STATE OF NORTH CAROLINA  
DEPARTMENT OF TRANSPORTATION

**Subject: Request for Modification to Section 404 Individual Permit and Section 401 Water Quality Certification** for the I-40/I-77 interchange improvements including I-40 from west of SR 2003 (Radio Road) to SR 2158 (Old Mocksville Road) and I-77 from south of SR 2321 (East Broad Street) to south of SR 2171 (Jane Sowers Road) in Iredell County. Division 12, TIP No. I-3819B. Debit \$570.00 from WBS 34192.3.2.

**References:** 1) Section 404 Individual Permit, Action ID No. SAW-2018-01504, issued January 21, 2020; 2) Section 401 Water Quality Certification No. WQC004203, NCDWR Project No. 20191006, issued November 19, 2019 and revised January 30, 2020.

The purpose of this letter is to request a modification to the United States Army Corps of Engineers (USACE) Section 404 Individual Permit and associated North Carolina Division of Water Resources (NCDWR) Section 401 Water Quality Certification for the above referenced project. This request letter includes a variance request for specific cross-pipes that will not be embedded, revisions to the drainage design, and modifications to permitted impacts.

PERMIT DRAWING  
SHEET 14 OF 67  
Rev. 11/02/2020

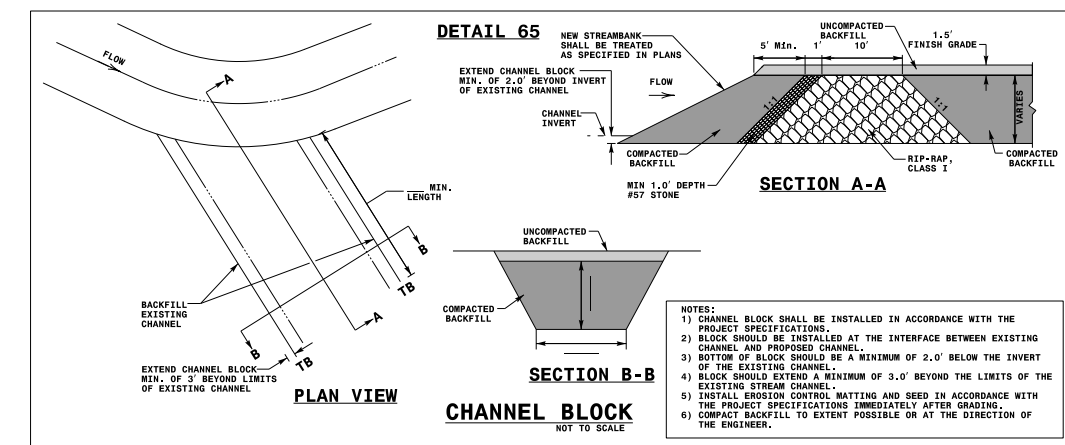
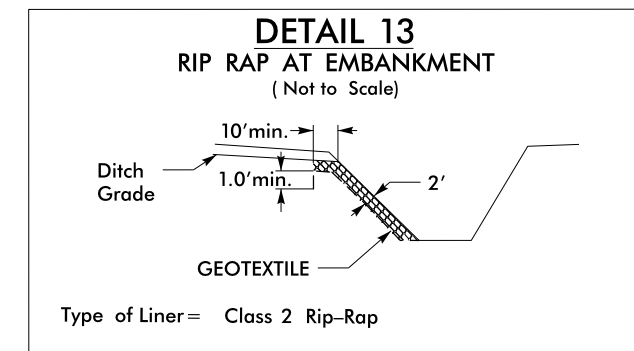
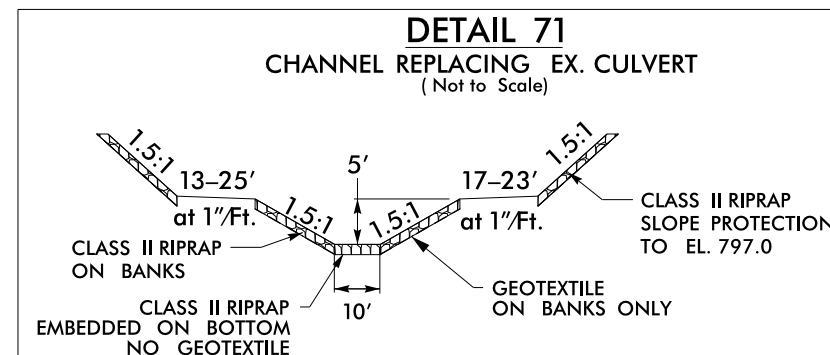
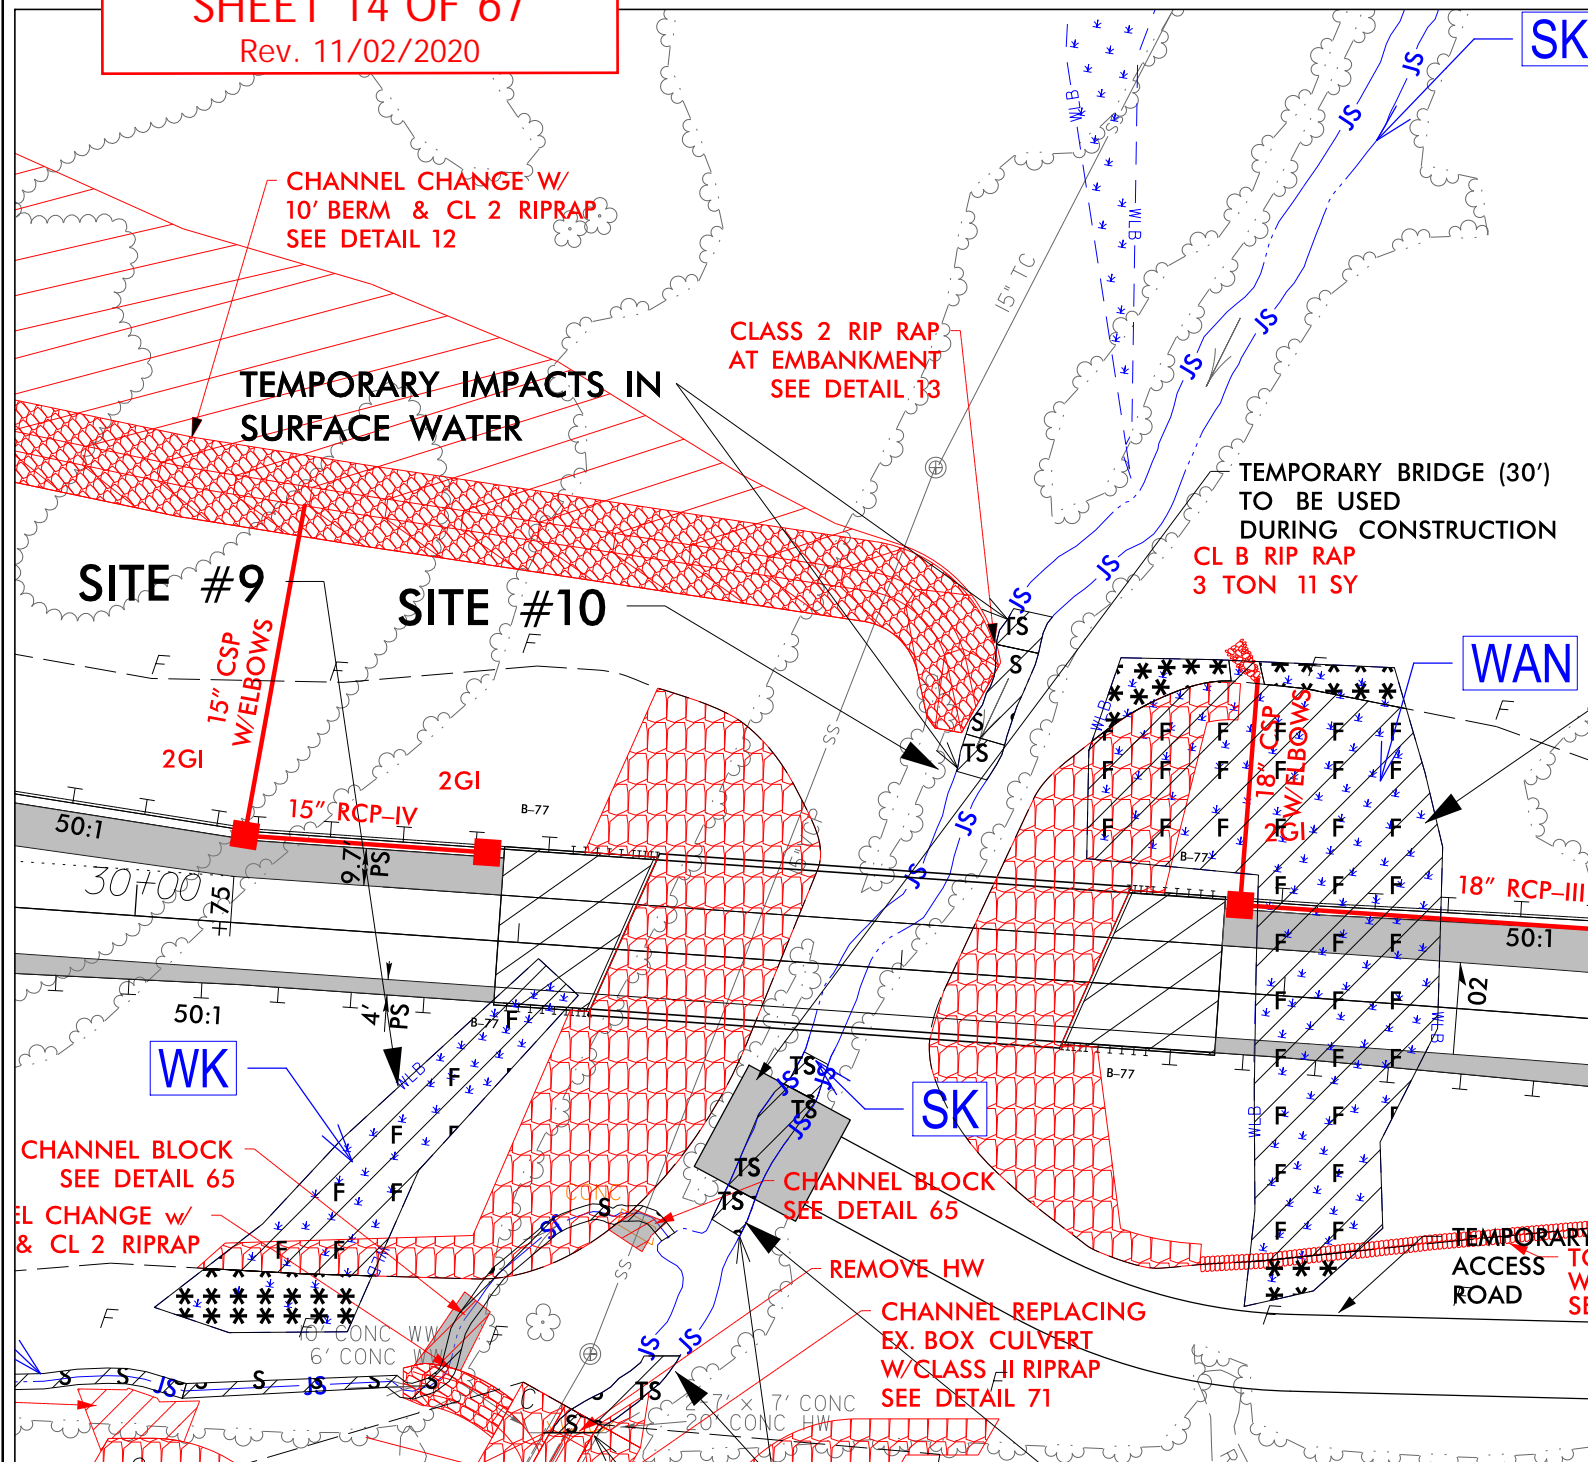
Site 9A (Permit Drawing Sheet 11 and 14) – At this site, a temporary work bridge that spans from top of bank to top of bank was installed for construction access to Site 9. In the approved permit, no impacts were included for the temporary work bridge, however, impacts have been revised to include 50 linear feet (0.01 acre) of temporary stream impacts to account for any temporary impacts to stream SK that may occur as a result of the temporary work bridge. There will be no permanent stream impacts at this location.

PERMIT DRAWING  
SHEET 21a OF 67  
Rev. 11/02/2020

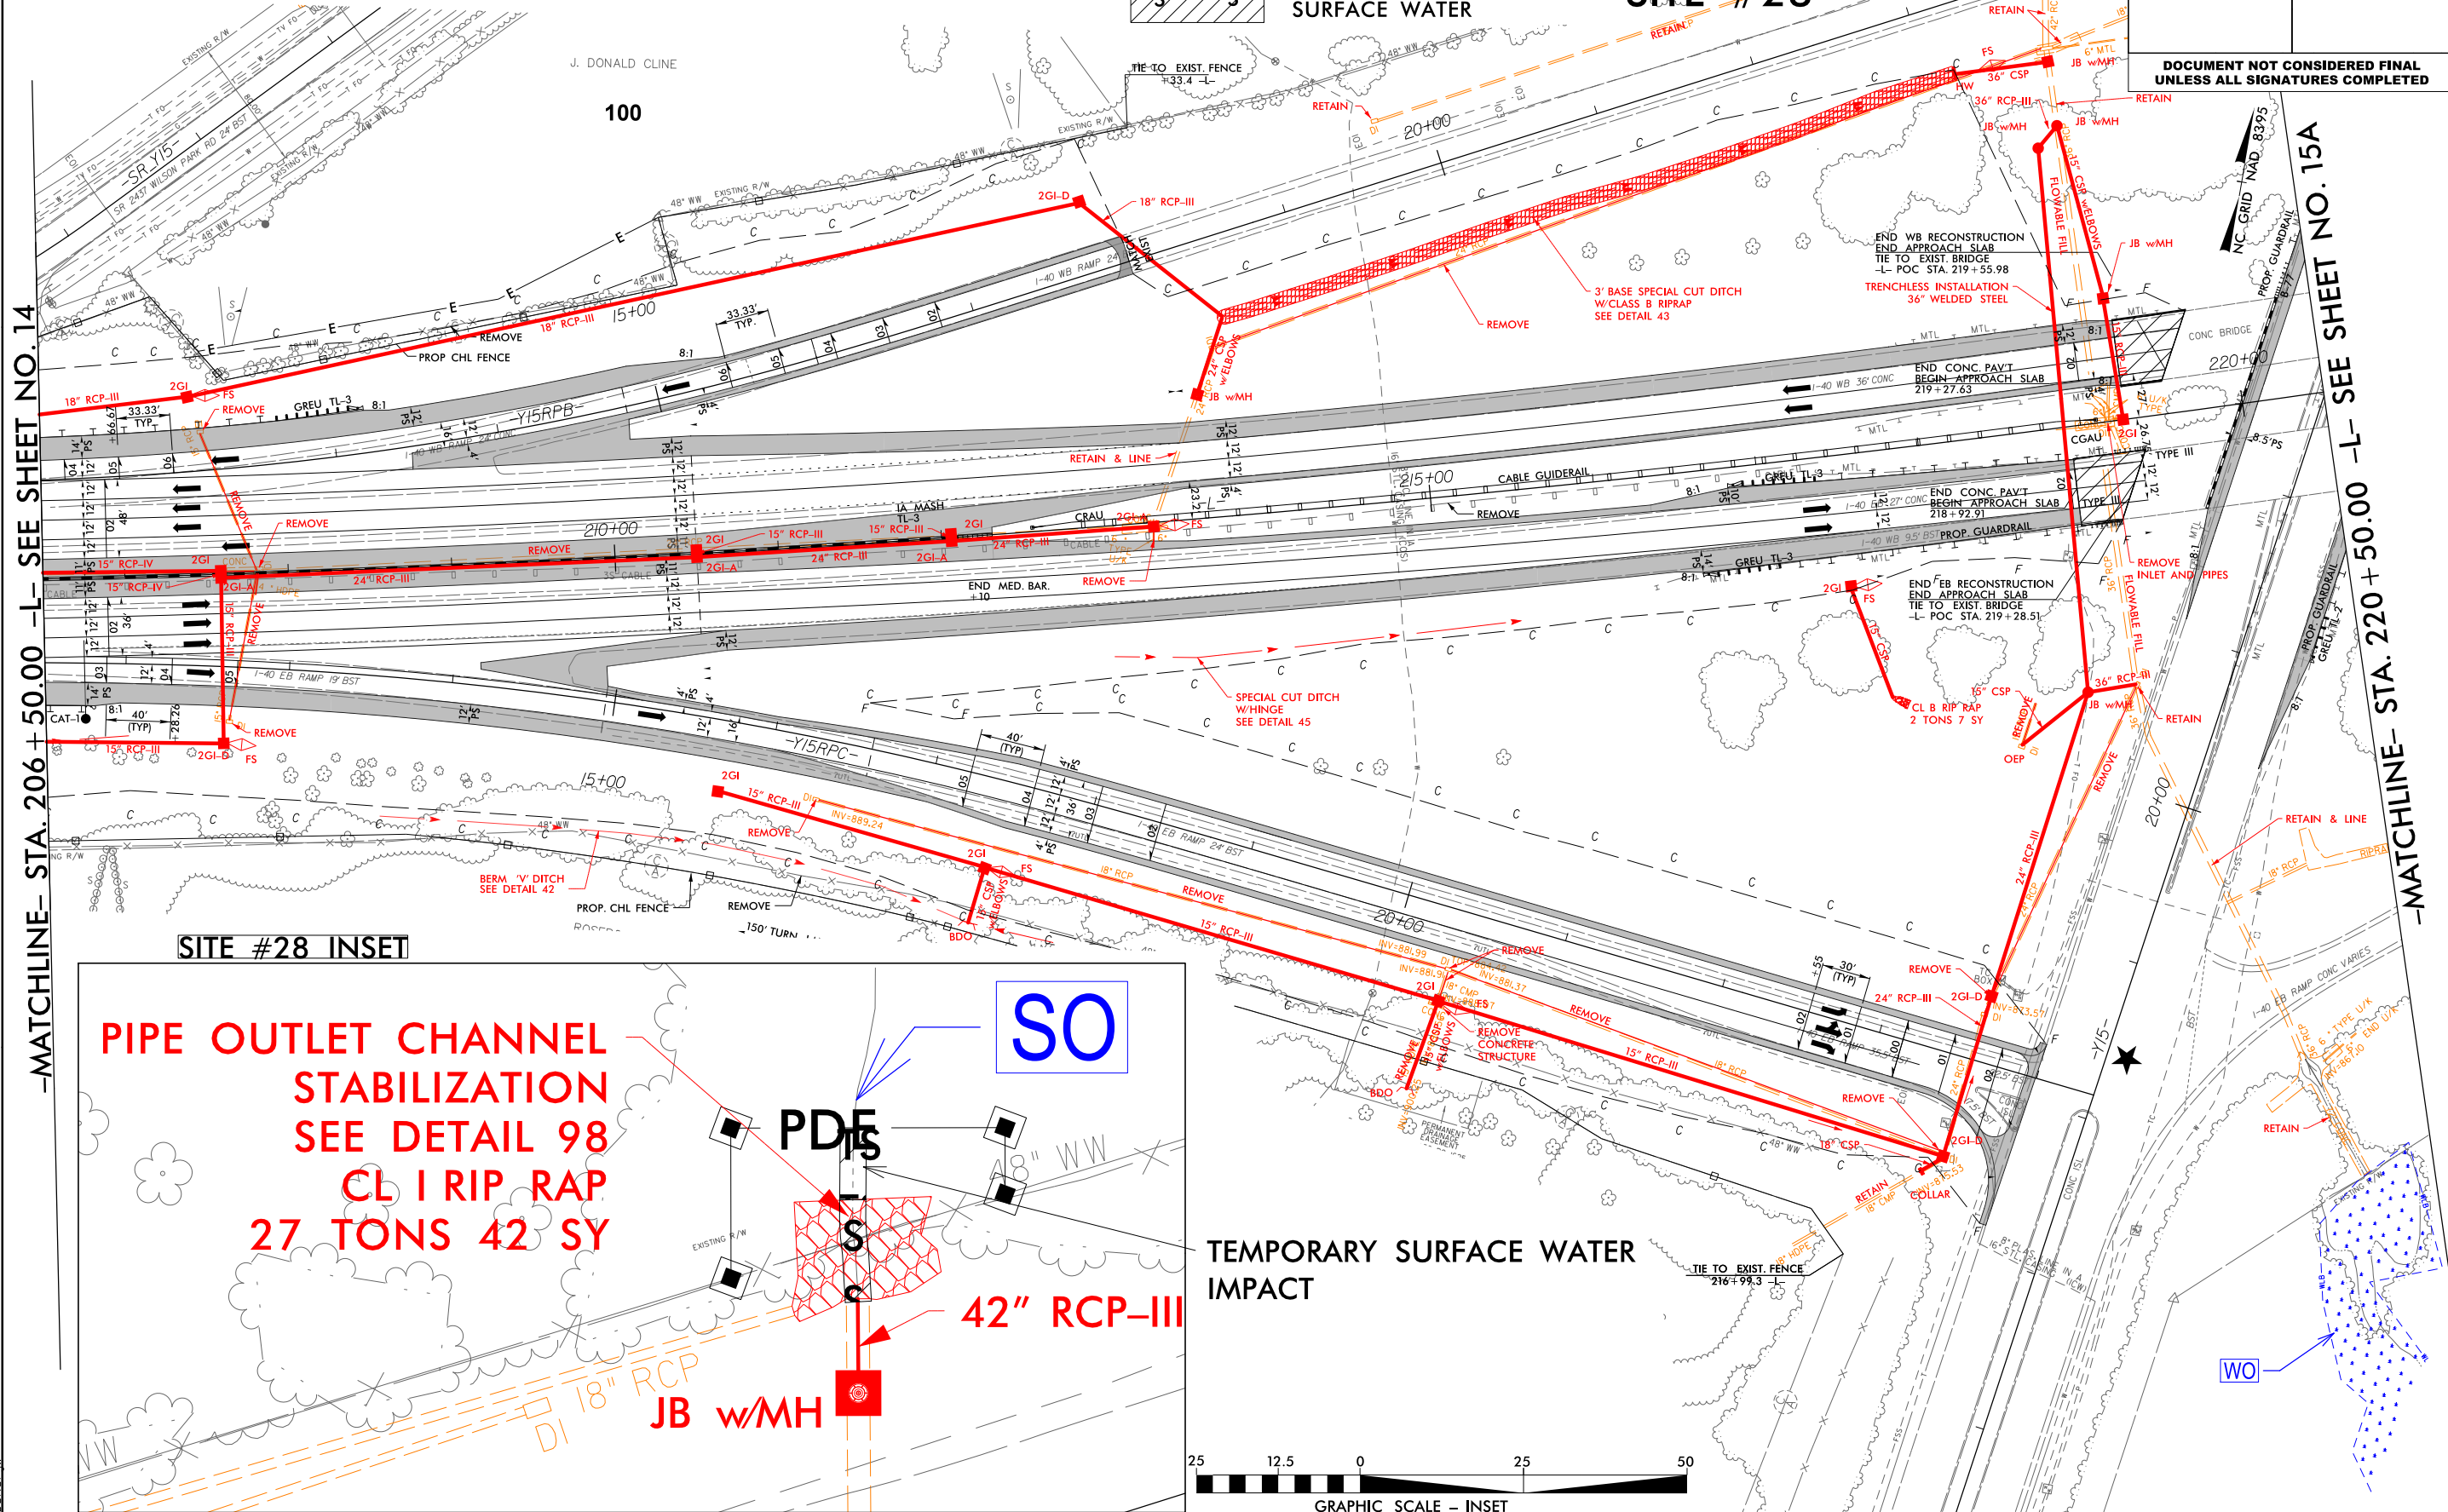
Site 28 (Permit Drawing Sheet 21a) – This site was added after it was determined the end of the existing 42” RCP outfall was structurally deficient and in need of replacement. The replacement of this section of pipe and installation of riprap outlet protection requires impacts to stream SO. At the outlet of the replacement pipe, Class I riprap will be installed in the stream bed and along the banks of stream SO for stabilization. The existing outlet in this location is perched which is being addressed through the use of a manhole drop structure in order to lower the proposed outlet to the streambed elevation. This will result in 16 linear feet of permanent stream impacts and 11 linear feet of temporary stream impacts that were not previously permitted.

PERMIT DRAWING  
SHEET 26 OF 67  
Rev. 11/02/2020

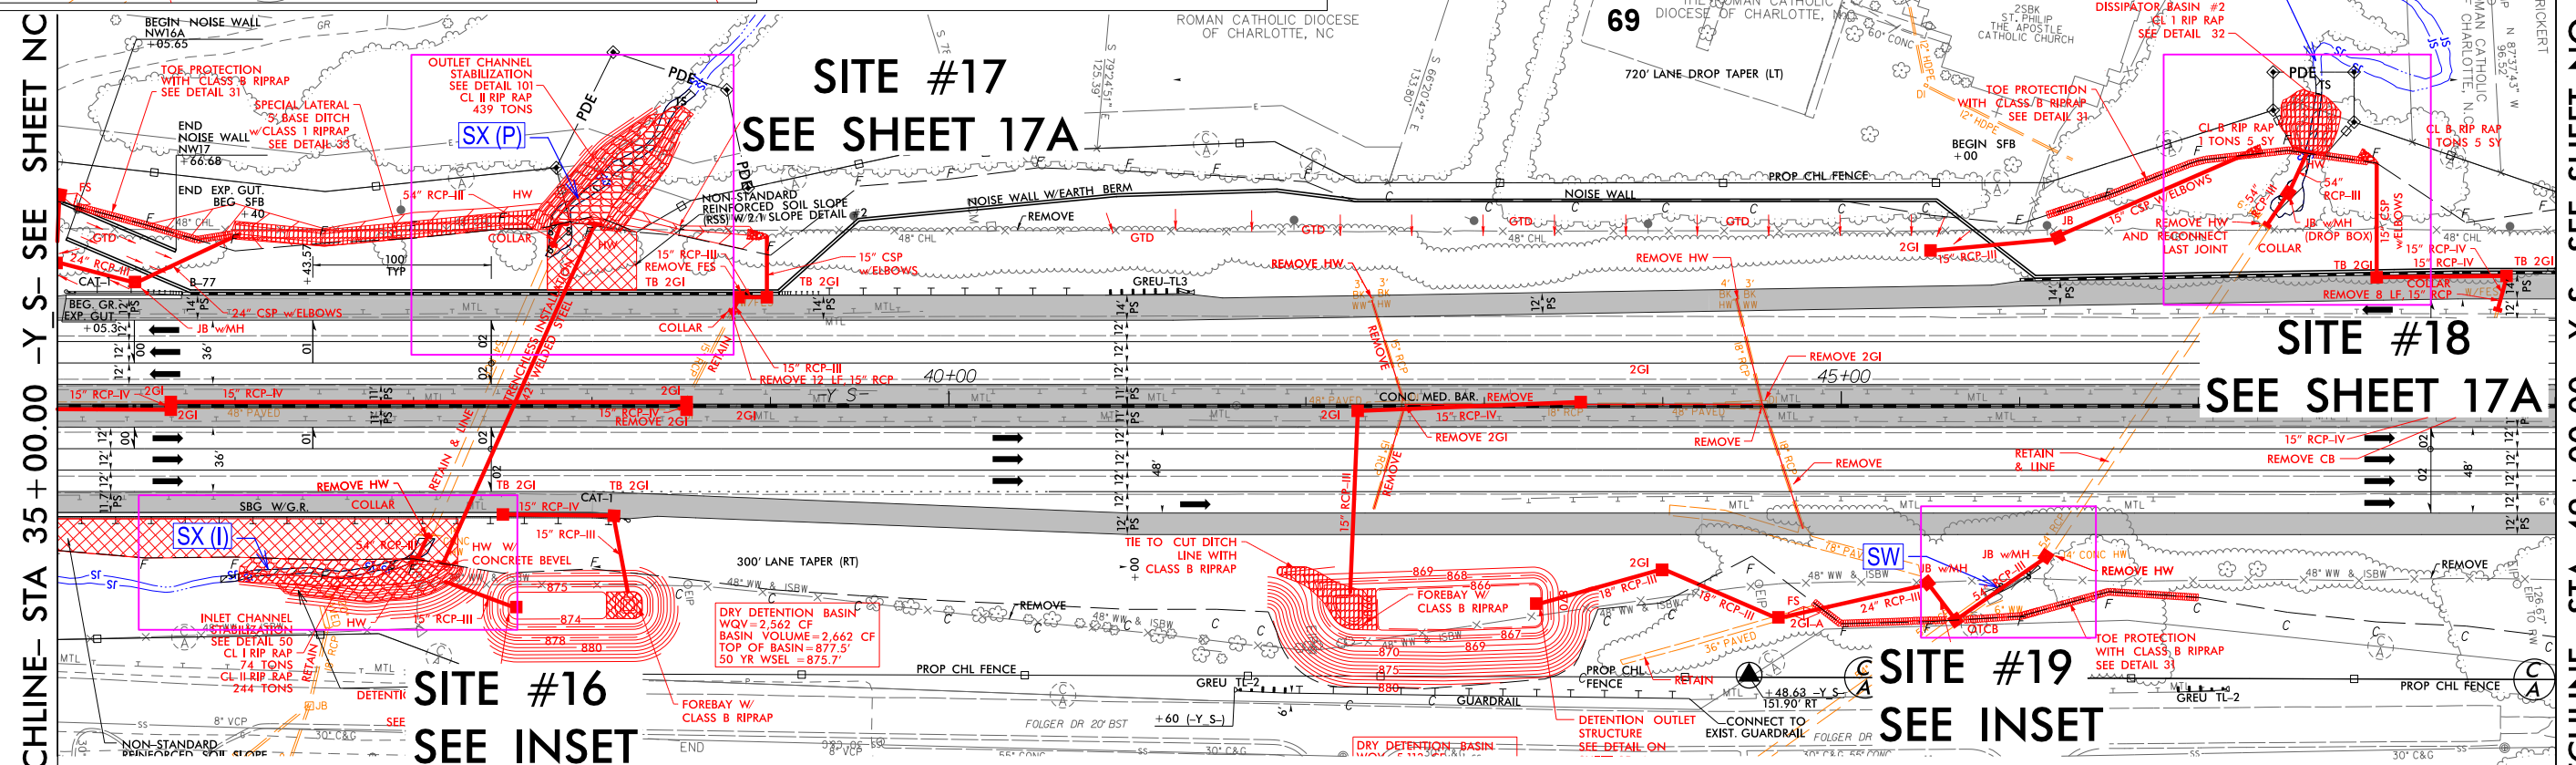
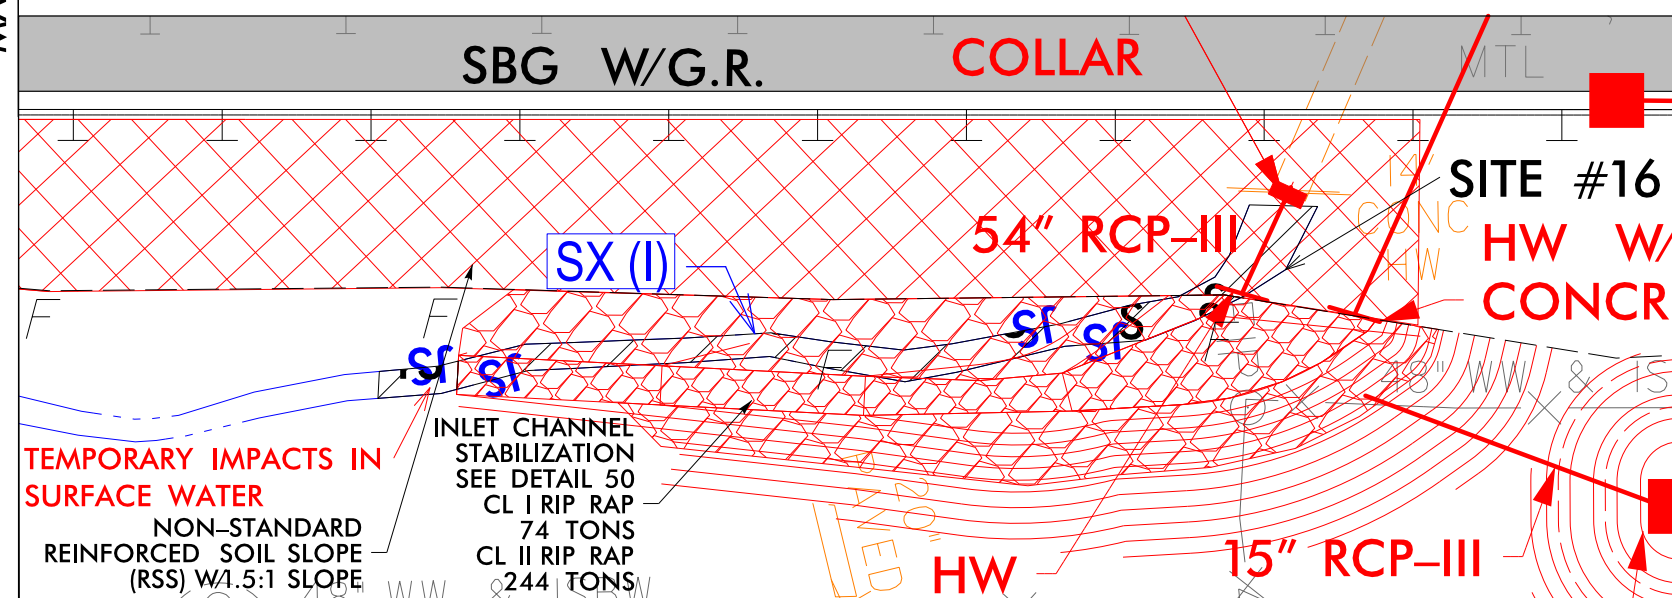
Site 16 (Permit Drawing Sheet 26) – Similar to the previous design, the impacts to stream SX at this site are due to the extension and supplement of an existing 54” reinforced concrete pipe (RCP) cross pipe. However, the pipe is now proposed to be lined. Otherwise there are no significant variations to the proposed design. Due to minor adjustments to the slope stake and headwall

configuration the impacts resulting from the pipe extension have increased from 13 linear feet to 15 linear feet, which is 2 feet of additional impacts. The permanent impacts due to bed stabilization have decreased from 99 linear feet to 98 linear feet. Overall, there is 1 foot of additional permanent stream impacts being proposed at this site compared to the previously permitted impacts. The design change will not result in any additional temporary stream impacts at this location.

Site 17 (Permit Drawing Sheet 26) – Similar to Site 16, the impacts at this site are due to extension and supplement of an existing 54” RCP cross pipe. However, the pipe is now proposed to be lined. Otherwise there are no significant variations to the proposed design. Due to minor adjustments to the slope stake and headwall configuration, the impacts resulting from the pipe extension have increased by 3 linear feet from 17 linear feet to 20 linear feet. The permanent impacts due to bed stabilization have decreased from 98 linear feet to 94 linear feet. Overall, there is 1 foot less of permanent stream impacts being proposed at this site compared to the previously permitted impacts. The design change will not result in any additional temporary stream impacts at this location.

Site 19 (Permit Drawing Sheet 26) – The design proposes to extend the existing 54” RCP and cover the existing stream channel with the roadway fill slope. The originally permitted permanent stream impacts were misclassified as 54” RCP extension and have been updated as roadway fill. The reclassification of impact type will not result in any additional permanent stream impacts at this location.
